UNITED STATES PATENT AND TRADEMARK OFFICE

APPLICATION NO.	FILING DATE	FIRST NAMED INVENTOR	ATTORNEY DOCKET NO.	CONFIRMATION NO.
09/460,552	12/14/1999	DAVID L. DEAN, JR.	HE0083	2615

Office Action Summary

DETAILED ACTION

FIG. 4

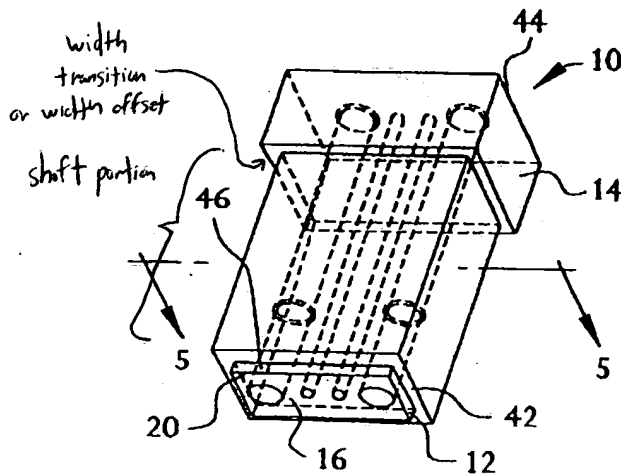
In regard to claim 1, Edwards et al. discloses (see Figures 4 and 5) a ferrule comprising at least one optical fiber bore (34) associated with a front surface (42) and a rear surface (44) of said ferrule as shown in Figures 4 and 5; first and second body portions (12, 14) extending at least partially between said surfaces as shown in Figures 4 and 5 and having respective widths as described in column 5, lines 60-61 and column 6, lines 53-56, a juncture of said body portions comprising an interface in the form of a parting line (i.e., where two body portions join) as shown in the lower portions of Figures

4 and 5, said parting line and said optical fiber bore extending longitudinally at least partially between said front surface and said rear surface as shown in the lower ends of Figures 4 and 5, and said parting line defining an offset of at least about 50 microns between first and second body portions as described in column 5, lines 60-61 and column 6, lines 53-56.

Regarding claim 5, Edwards et al. discloses that said parting line comprising a ledge as shown in lower portions of Figures 4 and 5.

Regarding claim 6, Edwards et al. discloses (see Figure 5) that said ferrule comprising multiple bores (34, 54) and defining a multifiber ferrule as shown in Figures 4 and 5.

In regard to claim 18, Edwards et al. discloses (see Figures 4 and 5) a ferrule comprising at least one optical fiber bore (34) extending from a front surface (42) to a rear surface (44) of said ferrule as shown in Figures 4 and 5; a shaft portion defining exterior surfaces of said ferrule as shown in Figure 4, said exterior surfaces at least partially extending longitudinally between said front and rear surfaces as shown in Figure 4; and a width transition, said width transition extending longitudinally along a portion (see lower portion of Figures 4 and 5), said ferrule shaft portion, said width transition comprising a width offset as shown in lower portion of Figures 4 and 5.

In response to this argument, the Examiner would like to point out that the limitation "a parting line" is not an actual physical structure of the ferrule but is a geometrical or virtual construct in order to describe the relationship between the first and second body portions. In a similar fashion, given the broadest reasonable interpretation, the ferrule of Edwards et al can plausibly read on the current claim language. If one examines, Figures 4 and 5 of Edwards et al, it is possible to interpret the juncture of the two body portions (12 and 14) comprising an interface in the form of a parting line, wherein said parting line and said optical fiber bore extend longitudinally at least partially between front surface and rear surface and that said parting line defines an offset of at least 50 microns between said first and second body portions (see Edwards et al., column 5, lines 60-62 and column 6, lines 53-56 for dimensions). In order to illustrate this reading based upon the current claim limitations, the Examiner has attached an annotated version of sheet 1 of 4 of US 5,926,596 showing how the limitations read on Figures 4 and 5.

In response to this argument, the Examiner refers the Applicant to the response above and to annotated version of sheet 1 of 4 of US 5,926,596 showing how the claim limitations of the shaft portion, width transition and width offset read on Figures 4 and 5.

FIG. 5

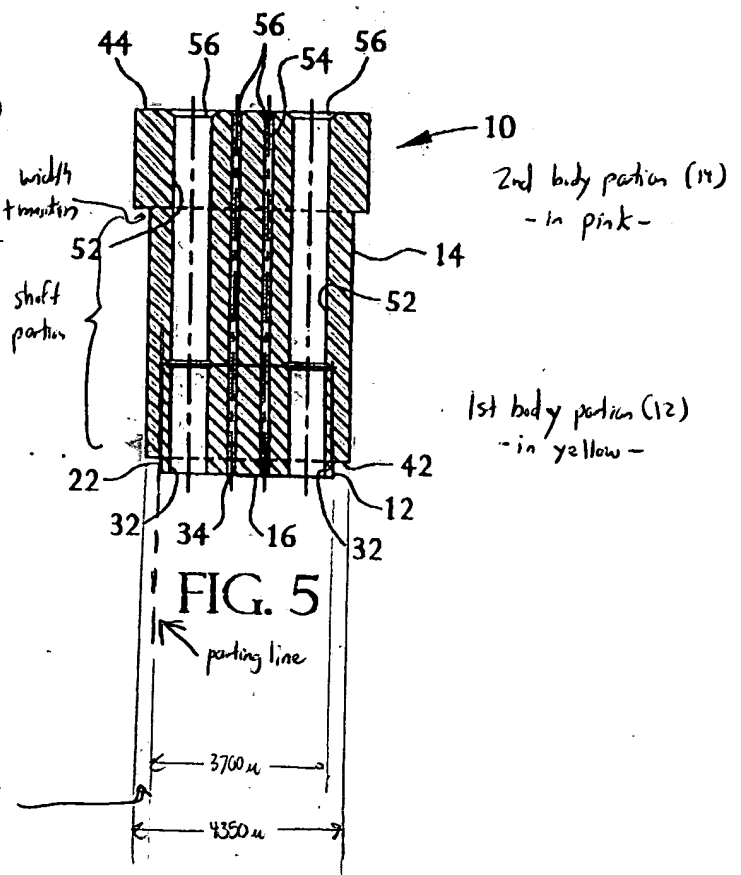
$$\begin{array}{r} 4350 \\ - 3700 \\ \hline 650 \mu / 2 \\ = 325 \mu \end{array}$$
